STAFF REPORT: APRIL 9, 2025 MEETING
APPLICATION NUMBER: HDC2025-00070
ADDRESS: 3417 SEMINOLE

HISTORIC DISTRICT: INDIAN VILLAGE

SCOPE: DEMOLISH GARAGE, ERECT GARAGE

Above and right: Applicant photos.

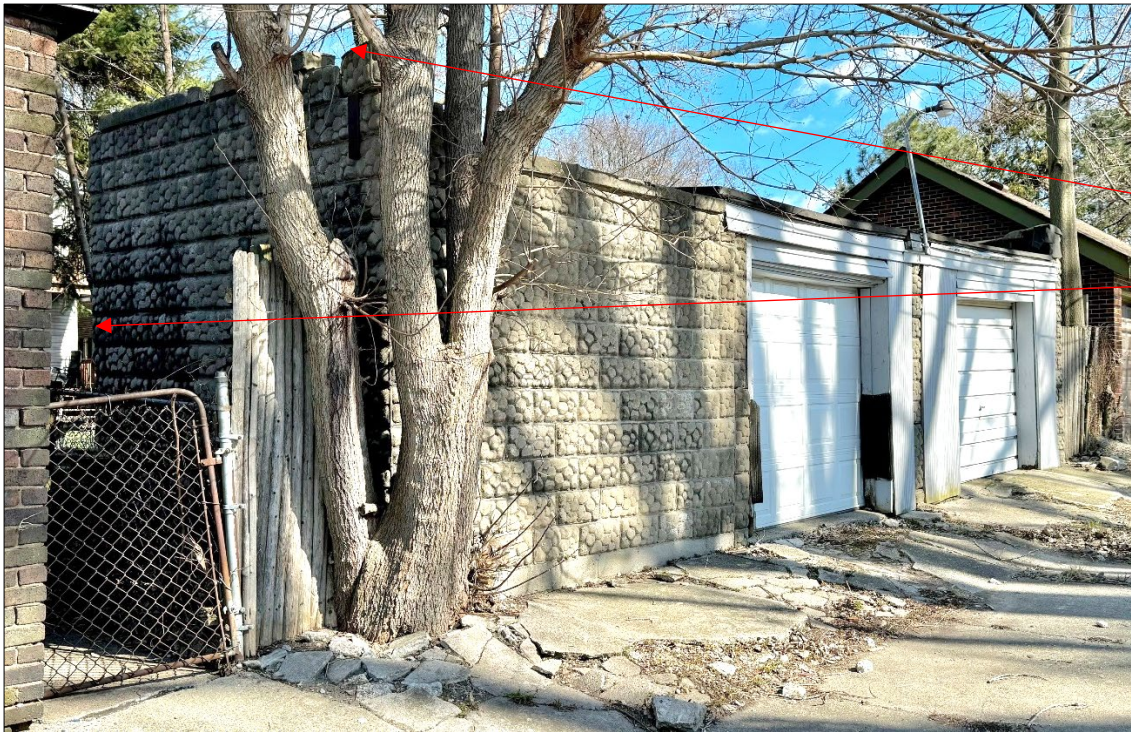
As shown on the Sanborn map on the previous page, the south bay (left side) was the largest of the three bays; the middle and north were about the same size.

At an unknown time, the roof and east wall of the northern bay were removed, and the overhead door opening was filled in with matching concrete block (likely reused from the now-demolished east wall). Staff didn't find Commission approval for this alteration.

Applicant photos

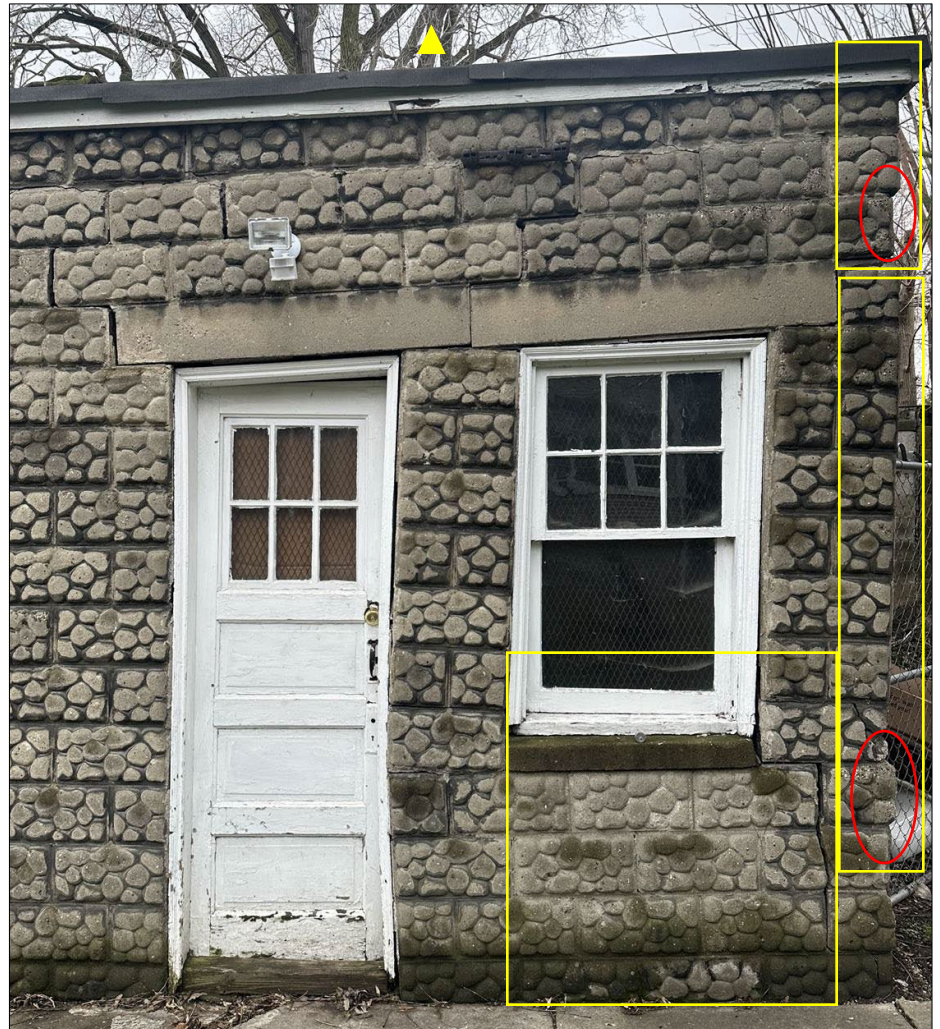
The areas adjacent and below the window show wood and stone deterioration which has created holes in the walls, further exacerbating mortar and block deterioration between the window to grade.

Also, this view shows how the top of the wall is leaning to the left and the block at the third course is inward of the upper two courses. Whereas the lower part of the wall is leaning towards the right and fourth block up from grade is outward from the upper and lower courses of blocks.

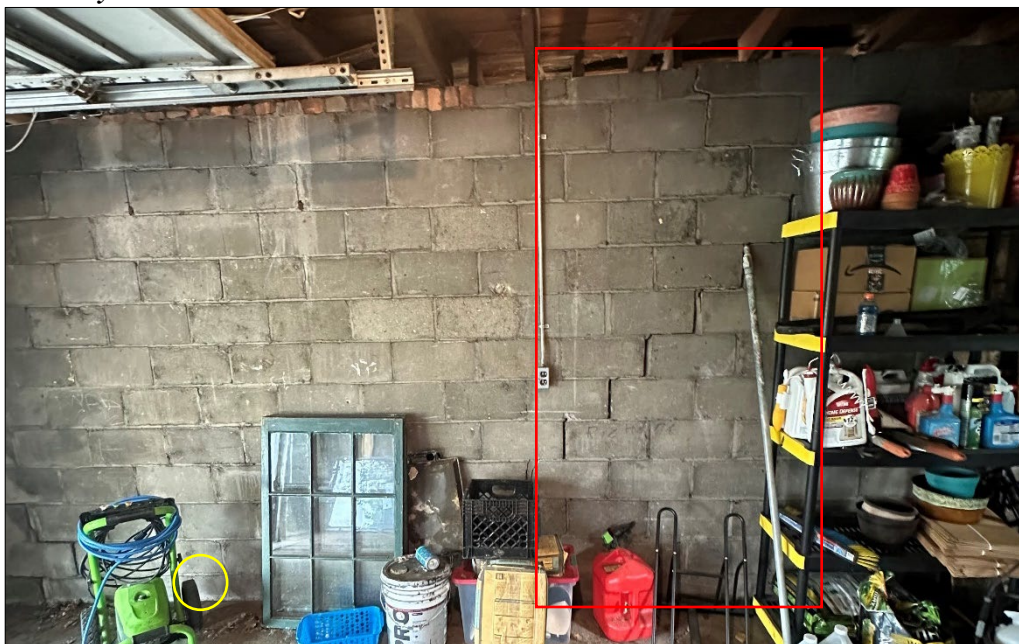
Middle bay - north interior wall (this interior wall is the exterior southern wall of the missing bay as seen on page 5 of this report).

Step crack and cracked block

Step cracks

Large step crack, broken blocks at top and near middle of wall

Broken block

Applicant's site plan. The outline of the original/existing garage is shown, as well as the footprint of the proposed garage (identified as "expansion area"). A new concrete drive (22' deep x 12' wide) is also shown extending into the rear yard.

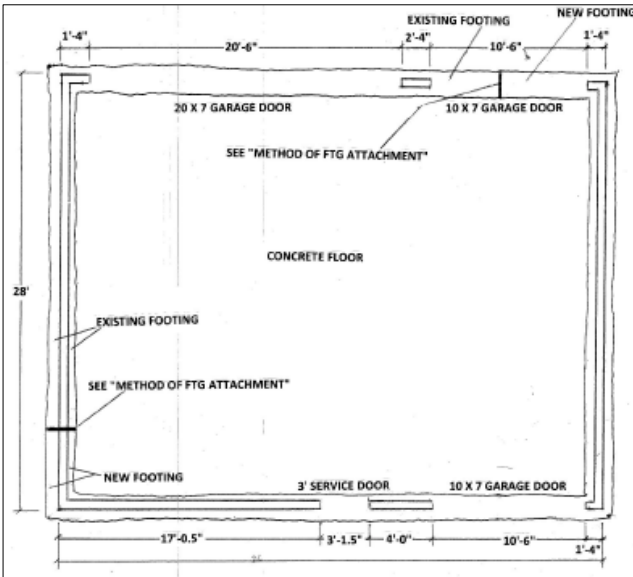
- An overhead garage door facing the house, without it being the primary opening which leads from the driveway, is not appropriate for this urban, early 20th century residential lot/historic district.

- An overhead garage door facing the house, without it being the primary opening which leads from the driveway, along with additional concrete driveway/parking pad, is not appropriate for this urban, early 20th century residential lot/historic district.

West elevation that faces Maxwell street. The double- single garage door arrangement is identical to the adjacent garage at 8215 Goethe.

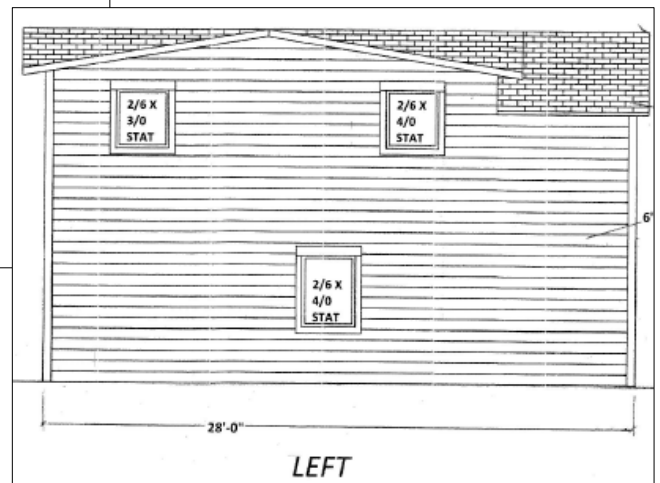
- The proposed garage is not compatible with the house and property, due to its massing/roof forms, incompatible window openings, inappropriate garage door opening to the rear yard and excessive concrete driveway surface.

South elevation.

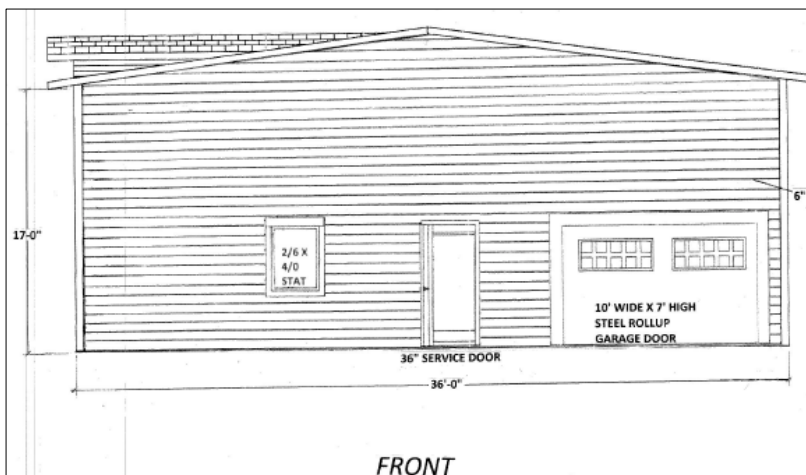
- Traditionally-designed dormers could be appropriate (rather than the extended height wall as shown on the south elevation) and would offer additional interior space.

- Staff suggests a side-gable roof to mimic the house's roof.
 - Traditionally-designed dormers could be appropriate (rather than the extended height wall as shown on the south elevation) and would offer additional interior space.

- A side-gable roof to mimic the house's roof should be considered.
 - Traditionally-designed dormers are appropriate to create additional interior space.
